ADDENDUM #1
SAFETY ANALYSIS REPORT
FOR THE
HN-100 SERIES 2 RADWASTE SHIPPING CASK
REFERENCING
10 CFR 71 TYPE "A" PACKAGING REGULATIONS

HITTMAN NUCLEAR & DEVELOPMENT CORPORATION
COLUMBIA, MARYLAND 21045

INTRODUCTION

Figure R-1. Cross Section of Upper Case

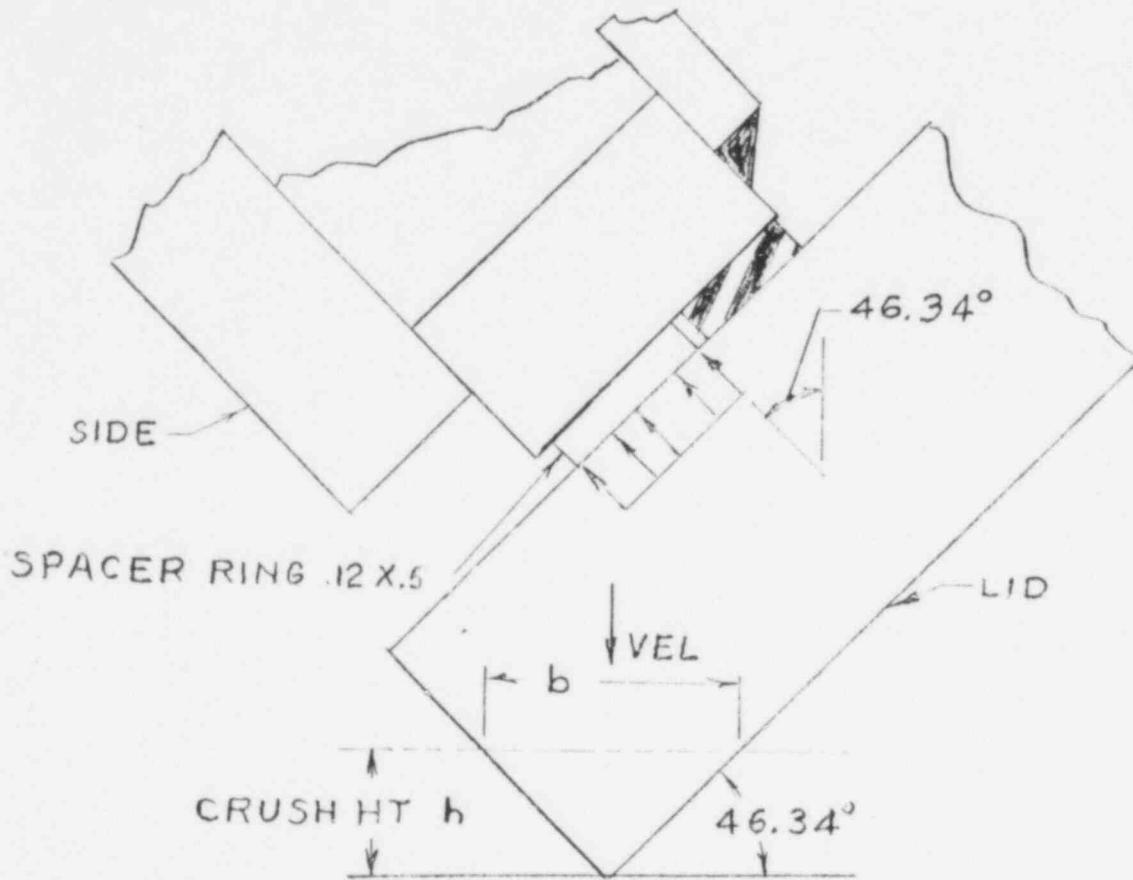
The gasket redesign requires a protective steel spacer. The spacer is in the form of a ring and is welded to the top of the case where the lid interfaces with the case. See Figure R-1. The lid compresses the gasket and bottoms on the spacer.

Figure R-2. Position of Cask at Edge Drop

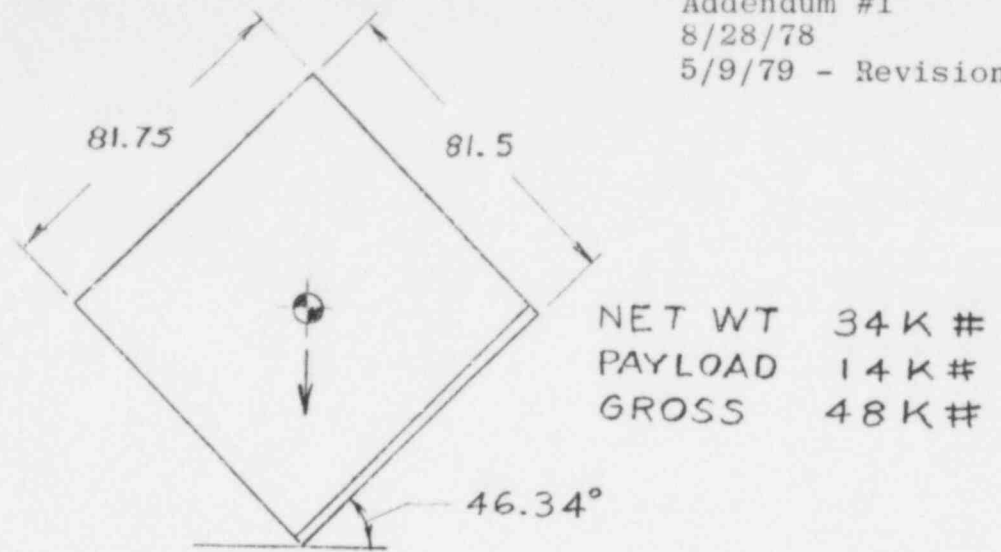
The worst case causing stress on the spacer is the edge drop. The deceleration is greatest here and the CG is directly over the edge.

The drop height of 12" and a gross weight of 48,000# yields a kinetic energy $KE = (12)(48000) = 576,000\#-in.$

The flow stress is 45,000#, giving a displacement V of:

$$V = \frac{576,000}{45,000} = 12.8 \text{ in.}^3$$

The volume displaced is in the shape of a prism with a triangular cross section of the length L of the edge.

$$L = (85.38)(\tan 22.5^\circ) = 35.4 \text{ in.}$$

The maximum deceleration A_g is twice the drop height H divided by the displacement height h .

$$A_g = 2H/h = (2)(12)/0.601 = 39.9g's$$

Deduct the mass of the lid and payload, since these do not contribute to loading on the spacer. Lid weight is 7000#, therefore net weight W_n is:

$$W_n = 34,000 - 7,000 = 27,000\#$$

Stress on 35.4 in. length of spacer is:

$$S_{sp} = \frac{P}{A} = \frac{(27000)(39.9 g's)(\cos 46.34^\circ)}{(0.50)(35.4)}$$

$$S_{sp} = 42,020 \text{ psi}$$

The bearing strength of A-36 is 90,000 psi. Therefore the M.S.:

$$M.S. = \frac{90,000}{42,020} - 1 = + 1.14$$
